APPLICATION NO.	FILING DATE	FIRST NAMED INVENTOR	ATTORNEY DOCKET NO.	CONFIRMATION NO.	
10/826,867	04/16/2004	Mark Colman	14389.2USU1	1444	
7590 10/12/2006			EXAMINER		
Merchant & Gould P.C.			STERLING, AMY JO		
P.O. Box 2903					
Minneapolis, M	1N 55402-0903		ART UNIT	PAPER NUMBER	
			3632		
			DATE MAILED: 10/12/2006

This is the **Final Office Action** for application number for application number 10/826,867, Extendable/Retractable Support Column, filed on 4/16/04. Claims 1-6, 10-19 are pending.

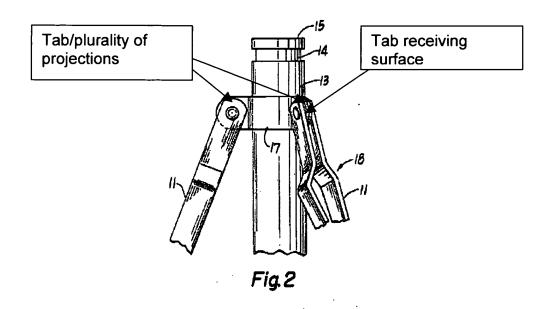
Claims 1, 10 and 16-18 are rejected under 35 U.S.C. 102(b) as being anticipated by United States Patent No. 3203657 to Thompson.

The patent to Thompson discloses a one piece integral structural unit having least three linked sections (11, 12), each linked section including a plurality of individual sections pivotally connected to one another in end-to-end relationship, each linked section having a surface parallel and spaced apart from the inner surface, the sections being positioned adjacent to at least two other linked sections, each individual section having an inner surface, a first end and a second end and a connection tab or plurality of projections (See Below) at the first end of the individual section, the connection tab extending inwardly of the inner surface of the individual section, and each individual section including a tab receiving surface (See Below) at the second end of the individual

section for engagement by the connection tab of an individual section of one of the adjacent linked sections.
